Technical Note 02: Relief to Rowstock Scheme Review

Site: Abingdon Road, Milton
Prepared by: CM
Approved by: JR
Date: 2nd August 2023

- 1.1 This technical note is prepared on behalf of local residents and provides an initial, high level review of what is referred to as the "Relief to Rowstock Scheme" (RRS). The RRS is being promoted by Oxfordshire County Council (OCC). The location of the RRS is illustrated on the plan below.

EASTBOUND LANE WIDENING WITH BUS PRIORITY - LAYOUT A

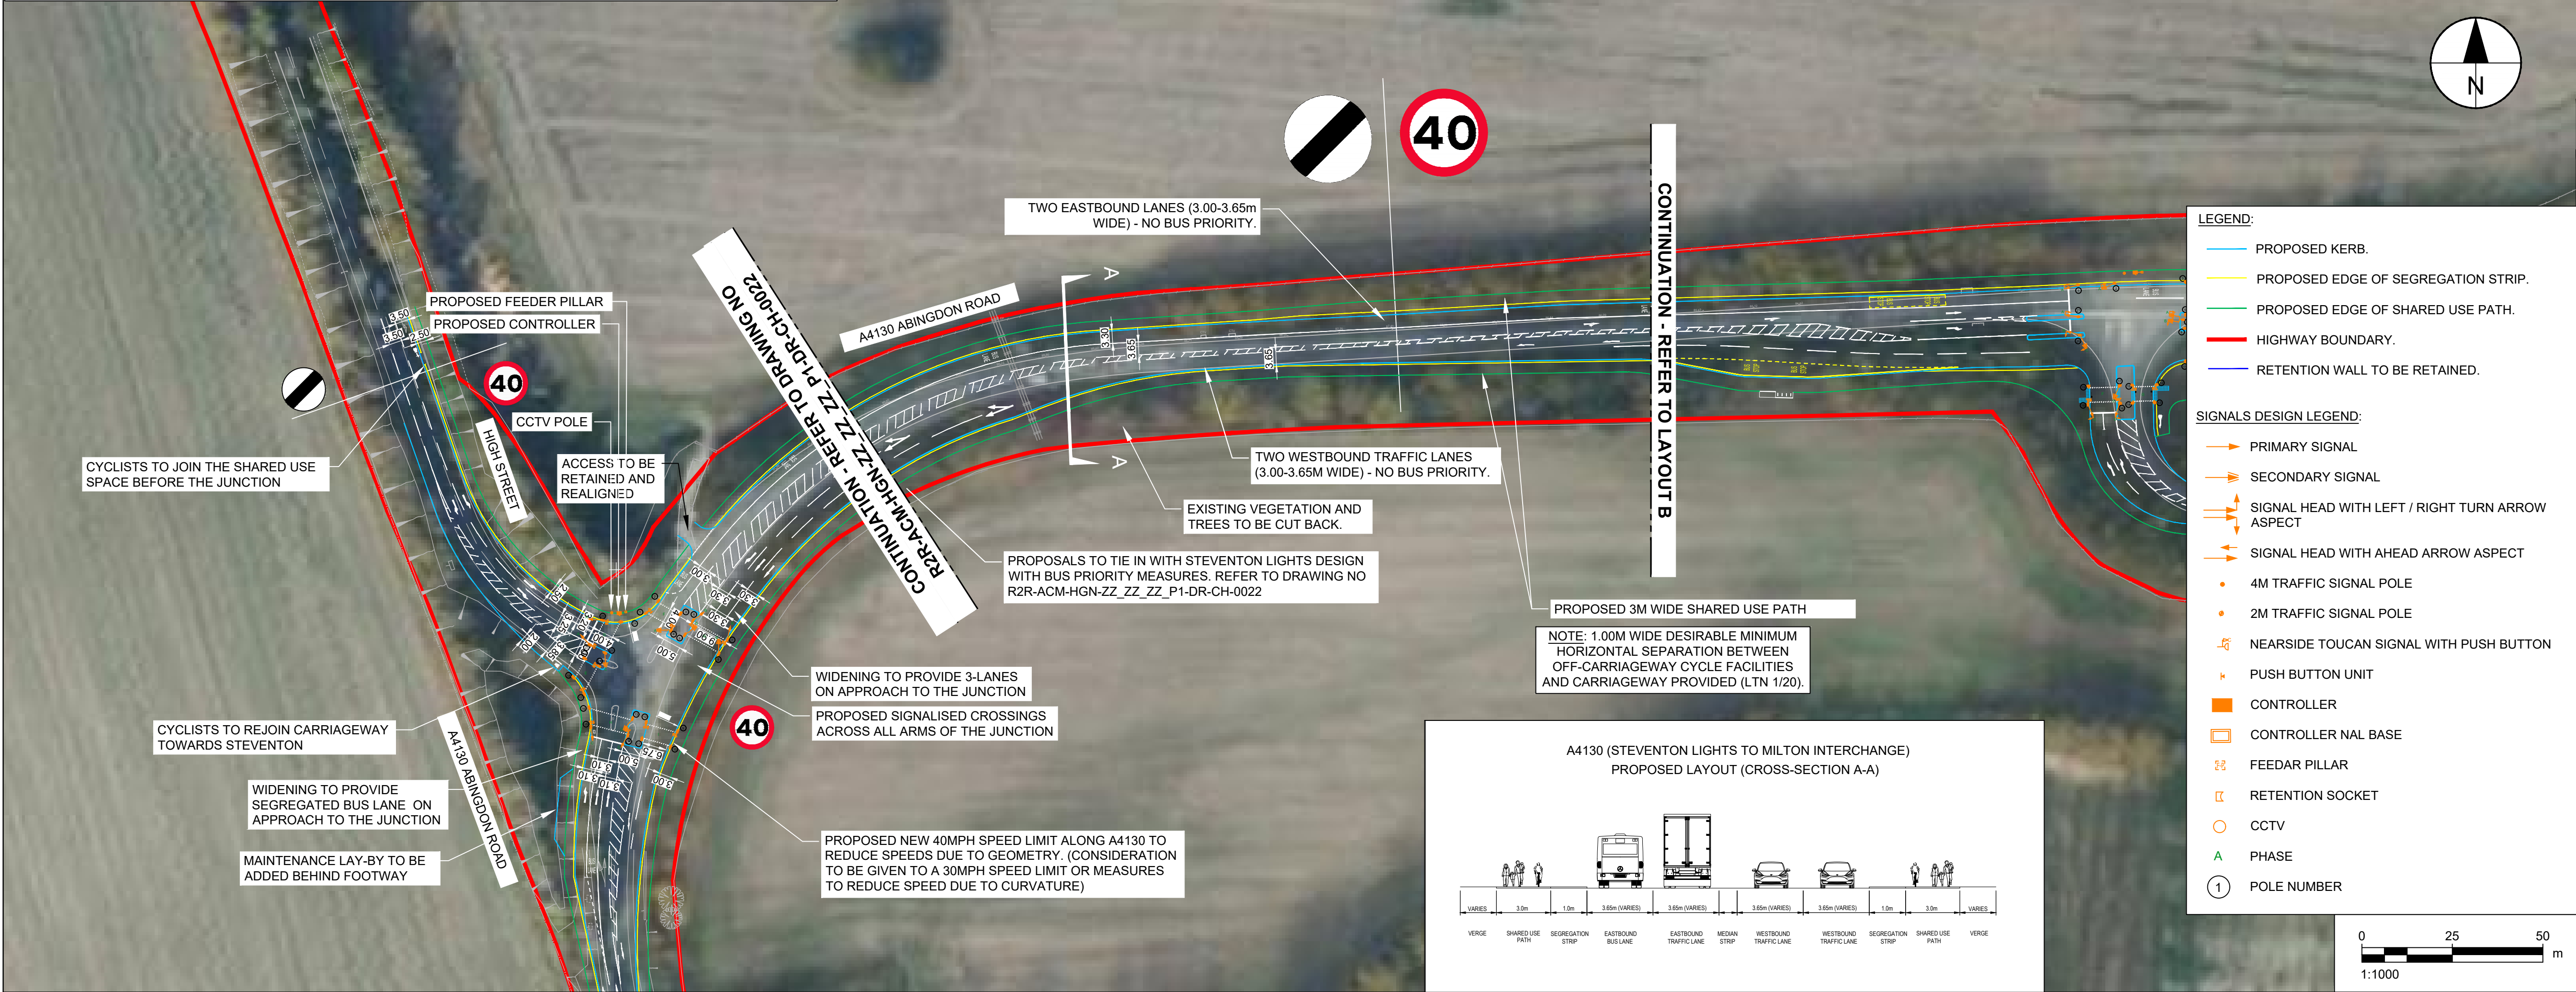
- 3.22 Provision is in place of a total of six metres for a bus lane and adjacent traffic lane leaves very little margin for error on the part of drivers. This is particularly true on bends, where additional width is typically required. No swept path analysis is provided and there is no evidence that interactions between buses and large vehicles and the associated safety implications have been considered.

- 3.23 The bus lane is likely to be attractive to cyclists given that it would provide a degree of segregation from traffic while avoiding leave the carriageway, negotiate a crossing and then re-join the carriageway later. The presence of cyclists in the bus lane must therefore be considered. LTN1/20 states:

"Where cyclists are using bus lanes, the lane should be at least 4m wide, and preferably 4.5m, to enable buses to pass cyclists with sufficient room. Bus lanes less than 4m in width are not recommended and widths between 3.2m and 3.9m wide should not be used."

- 3.24 The design of the proposed bus lane should be revised to comply with this guidance or justification provided as to why the current scheme is considered acceptable. As set out previously, the scheme does not include a continuous off-carriageway cycle route that extends to south along Abingdon Road or along High Street. It is unreasonable to assume that all cyclists will choose to leave the carriageway, potentially navigate multiple crossing points before re-joining the carriageway.

Figure 5: Steventon Lights - Option 02 - Junction Layout Drawing

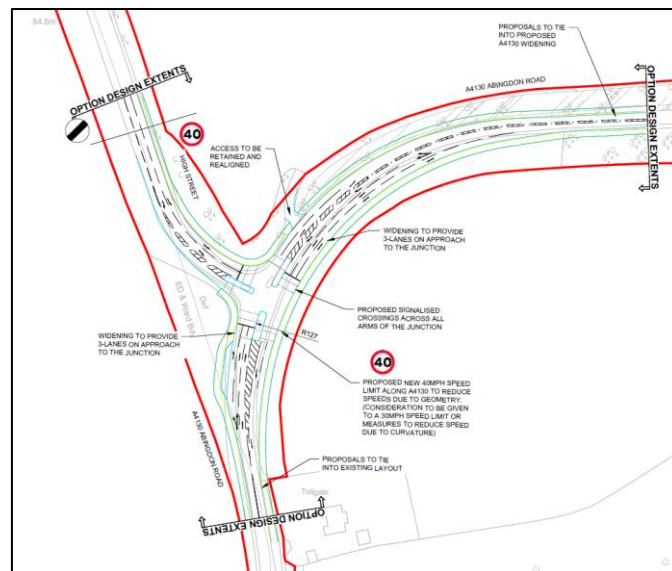
- 3.10 It is noted that no Advanced Stop Lines (ASLs) are included in the proposals. It is stated:
“Minor amendments were carried out to the Steventon Lights Option 01 junction option by removing the Advanced Stop Lines (ASL) for cyclists. This was carried out as it was deemed unacceptable for cyclists to be on the carriageway due to the speed limit being above 30mph.”

- 3.11 This statement is fundamentally untenable. There is no restriction on use of the carriageway by cyclists in this location. While current design guidance advises that on-carriageway provision would exclude most potential users in this situation it must be recognised that the proposed shared facilities do not form part of a continuous network. The fact remains that cyclists currently use the carriageway and will likely continue to do so rather than diverting onto a relatively short section of shared use path before being forced to re-join the carriageway again. The fact that cyclists will be approaching the junction on-carriageway clearly indicates that they will likely be comfortable negotiating the junction and are unlikely to consider the off-carriageway alternative as an attractive option due to the additional delay associated with it.

- 3.12 While the inclusion of off-carriageway cycle facilities is welcomed, particularly in that it may encourage the wider uptake of cycling, it does not absolve the designer of their responsibility to consider the safety of cyclists within the carriageway in locations where access is not restricted (i.e. the road in question is not subject to motorway regulations).

Drawing 2211083-04

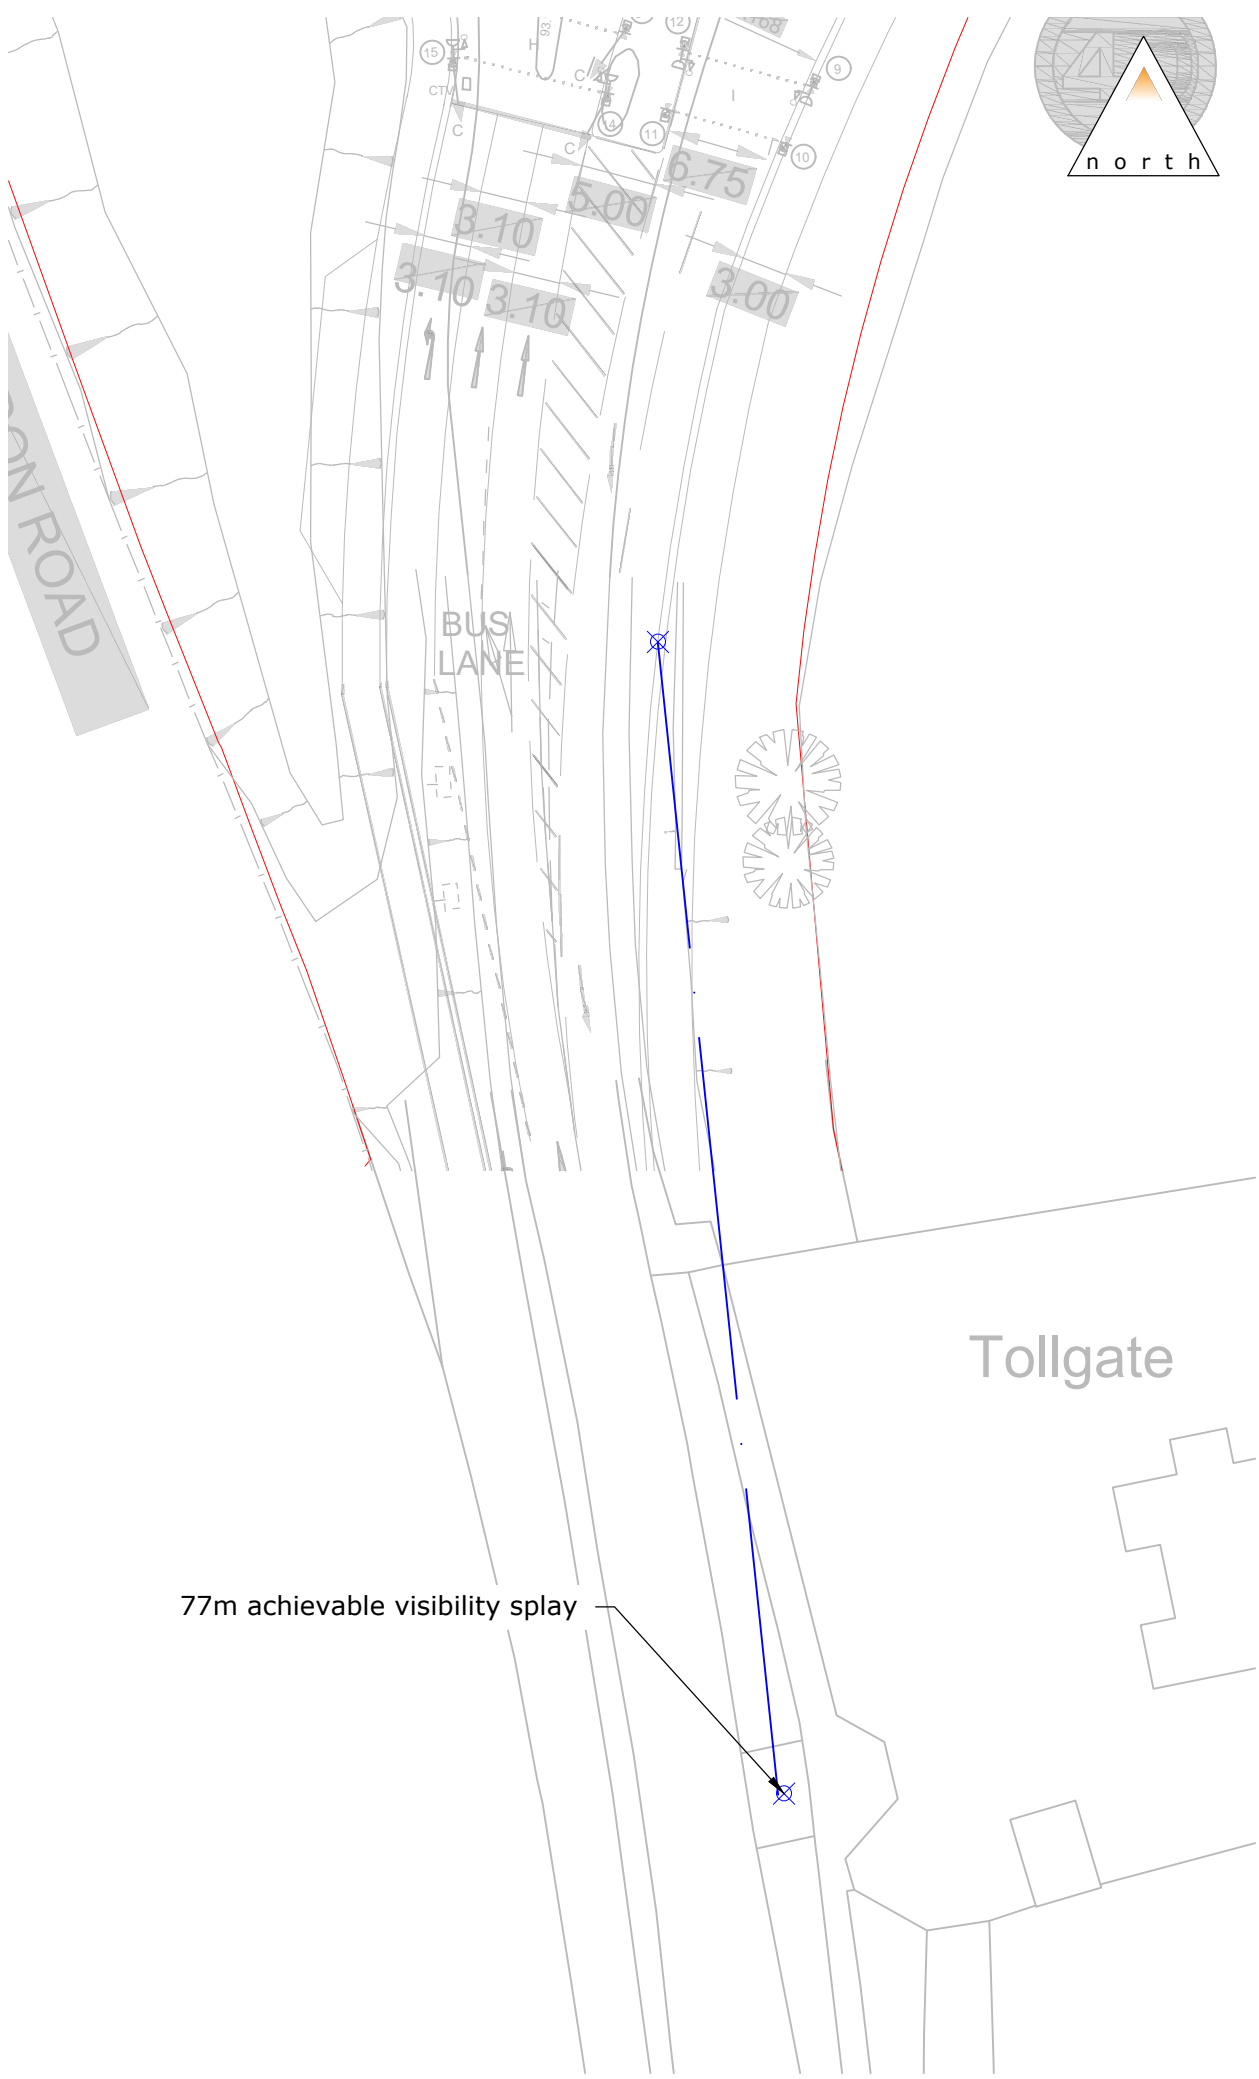
- 3.13 Of particular concern is the interaction of the scheme with Tollgate, a property located east of Abingdon Road, approximately 100 metres south of the High Street junction. As illustrated on drawing 2211083-04, included at **Appendix C**, A visibility splay of two by 94 metres is currently achievable looking north from the access. This figure aligns closely with the one step below desirable minimum figure for a 40mph design speed. The proposals reduce this figure to circa 77 metres, which falls below the one step below desirable minimum standard. The desirable minimum for a 40mph design speed is 120 metres.
- 3.14 With respect to visibility from priority junctions and direct accesses the DRMB states:
“Unobstructed visibility shall be provided at all priority junctions and direct accesses by a visibility splay formed between the following three points, as illustrated in Figure 3.4:

- 3.16 Based on the above, it is clear that the visibility currently available from this access falls below the desirable minimum standard and would require a departure to be agreed. Further, it can be seen that the proposals lead to a material reduction in the available visibility beyond the one step below the minimum desirable threshold, requiring a further departure to be agreed. There is no evidence that the safety implications of these changes have been considered.

- 3.17 Given that the access in question is not even included in the scheme drawings, it seems improbable that any meaningful "safety review" has been undertaken.
